Accessibility Survey

City of Downey Paramount Boulevard & 3rd Street

Date of Inspection
1/6/2017

Disability Access Consultants

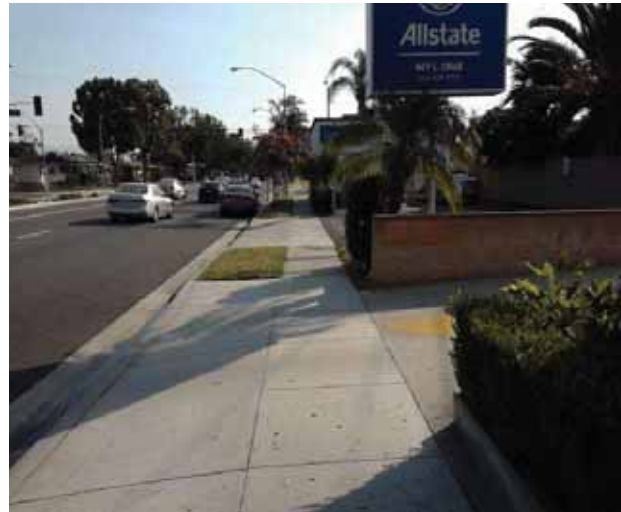
Cross slope at vehicular traffic is not compliant.

On-Site Finding 3.70 percent

Repave the surface to provide a compliant cross slope.

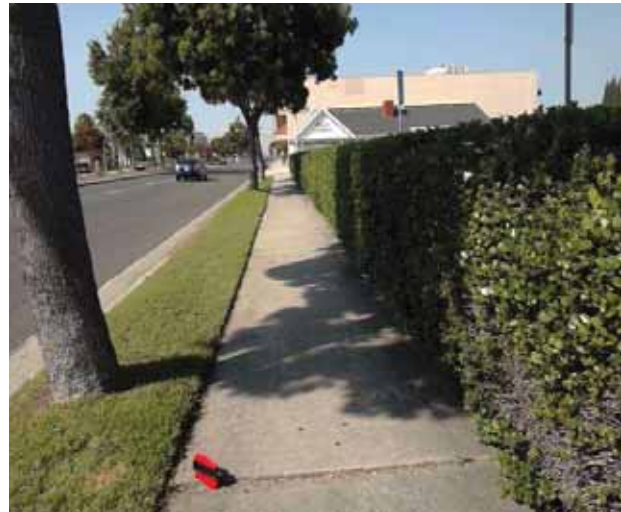
There is a change in elevation greater than recommended value.

On-Site Finding 0.62 inches

Ensure that the change in elevation is within the recommended value.
